**ETS 300 347-1**  
pr A1

**This draft amendment A1, if approved, will modify  
the European Telecommunication Standard ETS 300 347-1 (1994)**

**Signalling Protocols and Switching (SPS);  
V interfaces at the digital Local Exchange (LE);  
V5.2 interface for support of Access Network (AN);  
Part 1: V5.2 interface specification**

Page 249, figure L.36.7

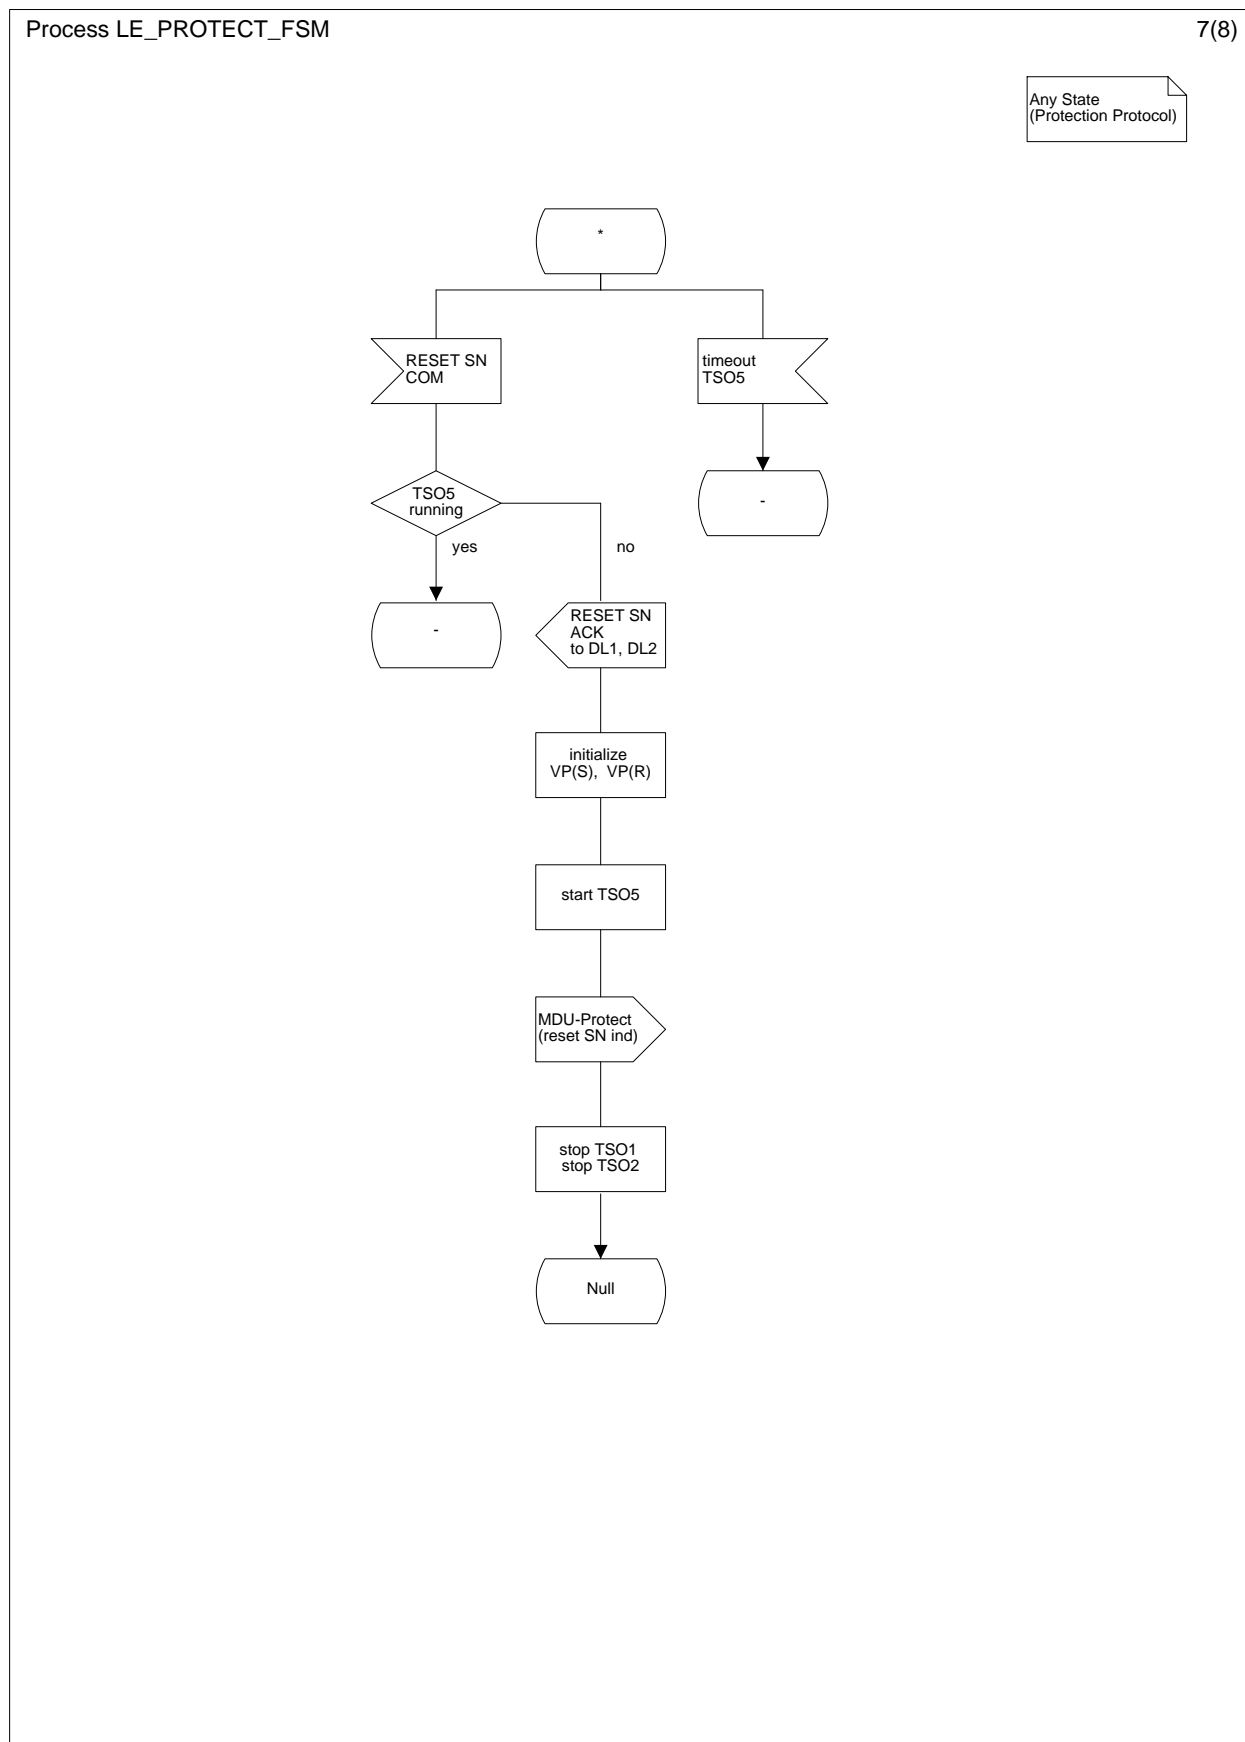
- Annex L, figure L.36.5: A stop of timer TSO2 is missing in the bottom left branch.
- Annex L, figure L.36.7: In the bottom diagram, the symbol for the message RESET SN ACK has the wrong direction.

Flip the output symbol "RESET SN ACK".
